Exeter Cycling Campaign response to the Clyst Valley Trail Consultation

Do you support the proposed route for **Section 1** of the Clyst Valley Trail?
(This section starts in Pinhoe (B3181) and links up to the old London Road/Blackhorse Lane near Clyst Honiton)

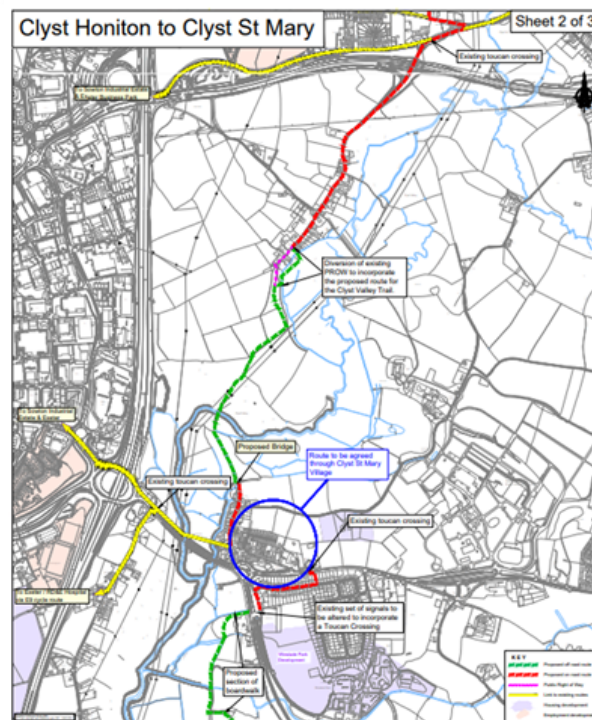
The design principles shared state that routes should be direct, however section 1 is anything but direct when considering where people want to cycle from and to. In the North, the sources of users would be Pinhoe/Westclyst, Broadclyst and Cranbrook. In fact, the consultation states "The 13 km (8 mile) route will link Pinhoe in Exeter with the Exe Estuary Trail." however, Pinhoe is one of the places which is unfortunately not connected with the trail in any way (as is Broadclyst). Figure A shows a journey from the proposed toucan crossing at the Poltimore turning in Westclyst to the East of Exeter Business Park (EDF, Oxygen House etc.) using the proposed Clyst Valley Trail route. Figure B shows that the same route using the road is just over half the distance of this proposed route with slightly more elevation gain.

We could potentially see some benefit in the current route only if the proposed route to Broadclyst Station was included and it also progressed onward to the railway station side of Cranbrook.

However, we propose that a far more useful and usable route to connect Westclyst to the rest of the trail would be utilising the Eastern Westclyst development (the development containing Co-op) to connect the Poltimore crossing directly to Langaton Lane. Ideally this would be via creating an entry from Mosshayne Lane, or if not then via Tuckwell Grove. This could then connect with the rest of the trail via the existing Tithebarn Lane cycle route as indicated in yellow on the section 1 map. Figure 3 demonstrates the same journey as earlier used is only 0.3 miles longer than the road route but crucially reduces the elevation gain and the gradient and avoids the busy and narrow Pinn Hill. As well as the benefit of this route being more direct and more desirable there are 2 additional benefits to this proposal. 1) this opens up access to the Langaton Lane green lane and provides an excellent commuter

route to the Science Park as well as the East of Exeter Business Park employment areas. 2) Provided a safe segregated connection was provided between the Poltmore crossing and the entry to this route this would avoid utilising Poltmore Way.

Do you support the proposed route for **Section 2** of the Clyst Valley Trail?
(This section links Blackhorse Lane near Clyst Honiton to Clyst St Mary)

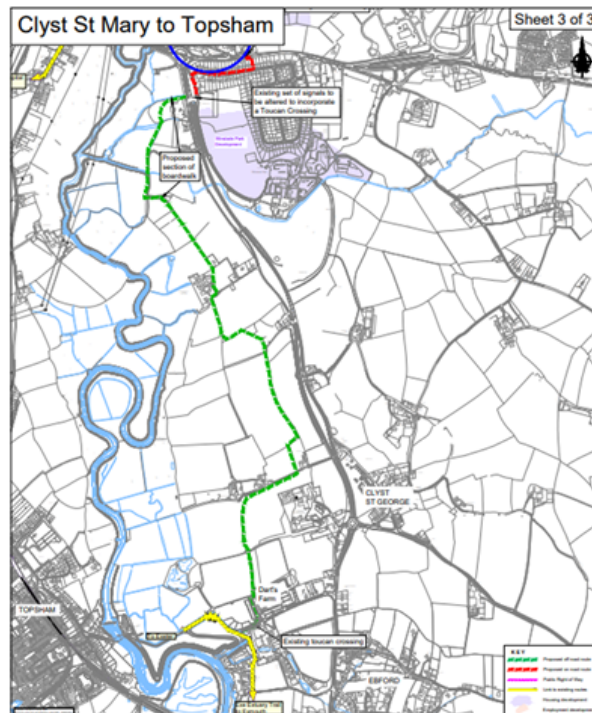
We recognise that the route through Clyst St Mary is yet to be decided, however the entry and exit routes shown here suggest that there is no plan to make this section direct. Any route should be direct and coherent as stated in the design principles and if needed a priority toucan crossing created across the A3052.
